CFC Percy St. Auburn

13 Percy Street, Auburn, NSW 2144

S4.55 - AMENDMENT LIST

ISSUE FOR S4.55

Drawing Title:
Ground Floor Plan

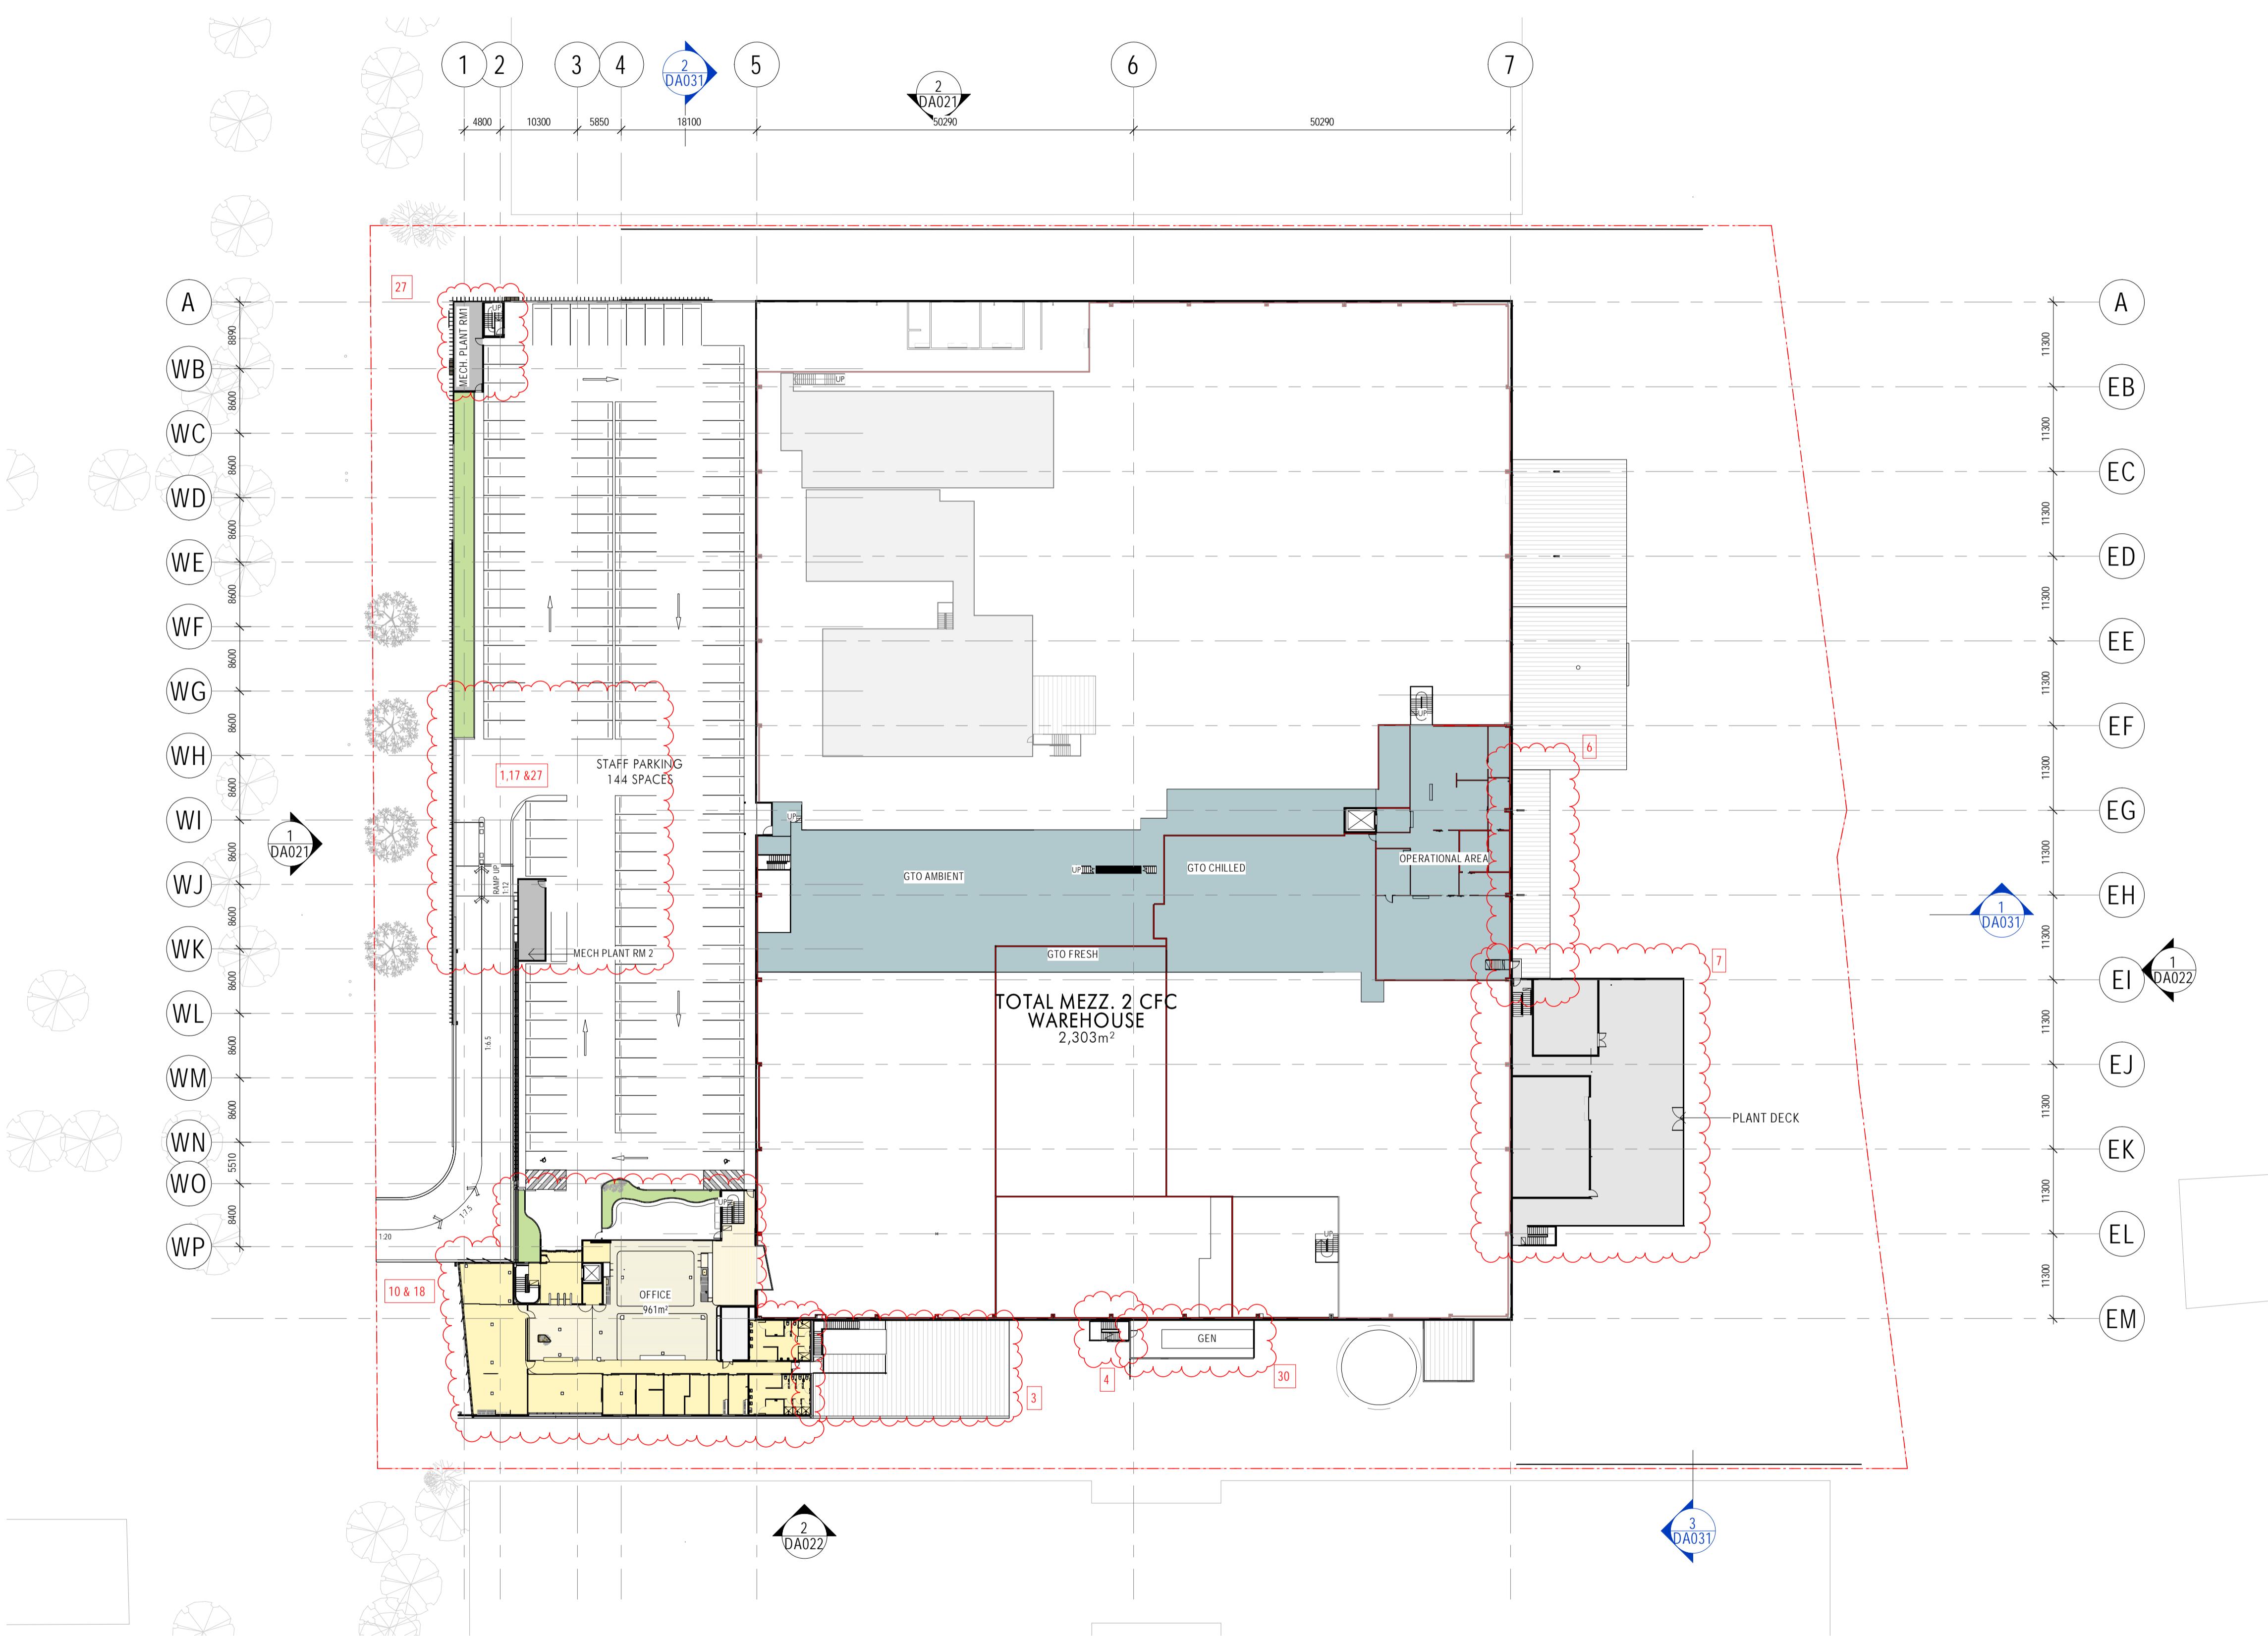
1. Carpark layout change due to additional mech. plant rooms & boomgate
2. Extension of roof over L1 office entry
3. Added external egress stair, awning over DTB bays and plant deck

4. Added external egress stair to access mezz. floors and roof
5. Added mech. exhaust & plant on roof & removed translucent roof sheets
6. Inbound dock awning is reduced

7. Added mech & refrigeration plant rooms on rear elevated plant deck, and associated egress stair
8. Added removal of existing concrete channel in demolition

9. Additional DTB store and DTB bays, including changed configuration of DTB bays
10. Office internal layout amended
11. Added landscape area, aluminium screen & gates

12. Southern plant area layout changed as following
 - Minor change to solar and switch room layout
 - Sub & HVAC updated
 - Permanent generator reduced to single large gen. Portable gen is added

- Diesel tank is added for backup generators
 - Armco is added around sub & sprinkler plant area
13. Precast wall is erected higher to support the rear elevated plant deck

14. Maintenance and wash bays are added
15. Added an external stair to inbound dock area
16. Security gates added
17. Boom gates added
18. Minor enlarged L1 office lobby & additional stair next to rec area

19. NOT USED
20. Mech. Louvre added
21. Heavy duty guardrail added to suspended slab edges
22. Replaced transparent wall sheeting to Longline metal cladding

23. Pickup graphic extended
24. CFC sheeting is removed from Office ground elevation
25. NOT USED
26. Outbound Loading dock size & Van parking size increased (TBC)

27. Two mechanical plant rooms on carpark level added
28. Added 3 flag poles
29. Added 2 lightning poles
30. Added generator on slab above switch and solar rooms
